## Second Revision No. 8154-NFPA 70-2021 [ Global Comment ]

**Article 210 Branch Circuits NotOver1000 Volts ac, 1500 Volts dc, Nominal**

## Second Revision No. 8155-NFPA 70-2021 [ Global Comment ]

### Article 235 Branch Circuits Over 1000 Volts ac, 1500 Volts dc, Nominal

**Figure 210.52(C)(1) Determination of Area Behind a Range, Counter-Mounted Cooking Unit, or Sink.**

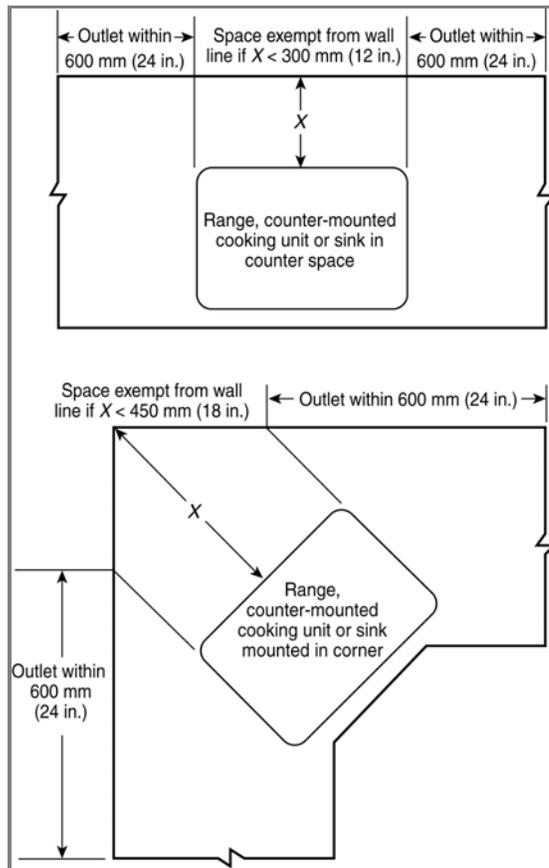
Revise 210.52(C) in accordance with the following:

*Exception: Receptacle outlets shall not be required directly behind a range, counter-mounted cooking unit, or sink in the installation described in Figure 210.52(C)(1).*

*Exception No. 1: Receptacle outlets shall not be required directly behind a range, counter-mounted cooking unit, or sink in the installation described in Figure 210.52(C)(1).*

*Exception No. 2: Where a required receptacle outlet cannot be installed in the wall areas shown in Figure 210.52(C)(1), the receptacle outlet shall be permitted to be installed as close as practicable to the countertop area to be served. The total number of receptacle outlets serving the countertop shall not be less than the number needed to satisfy 210.52(C)(1). These outlets shall be located in accordance with 210.52(C)(3).*

[NO CHANGES TO FIGURE]
